APPLICATION NO.	FILING DATE	FIRST NAMED INVENTOR	ATTORNEY DOCKET NO.	CONFIRMATION NO.
10/765,391	01/28/2004	Anthony Di Bitonto	B0224.0079	2535

Office Action Summary

10/765,391

FIG. 6

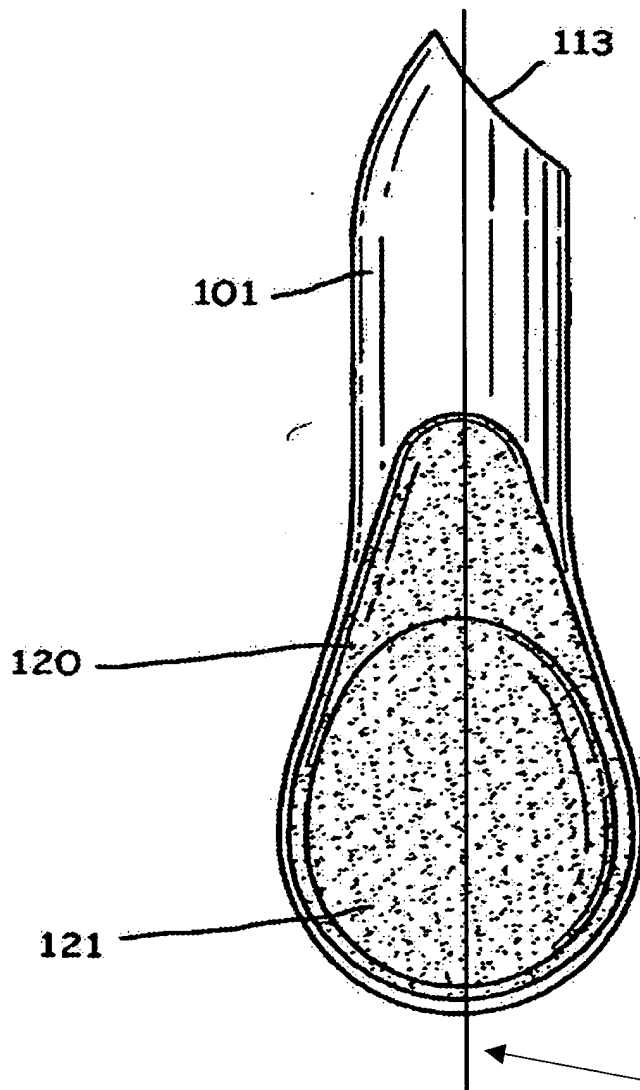
-In claim 8 the cutting edges are offset from the central longitudinal axis of the top and bottom members.

Regarding claim 8, claim 8 states the cutting edges 113 being offset from a central longitudinal axis of the top and bottom members. However in Fig. 6 the cutting edges are on the central longitudinal axis of the top and bottom members. It is unclear where the location of the cutting edges is.
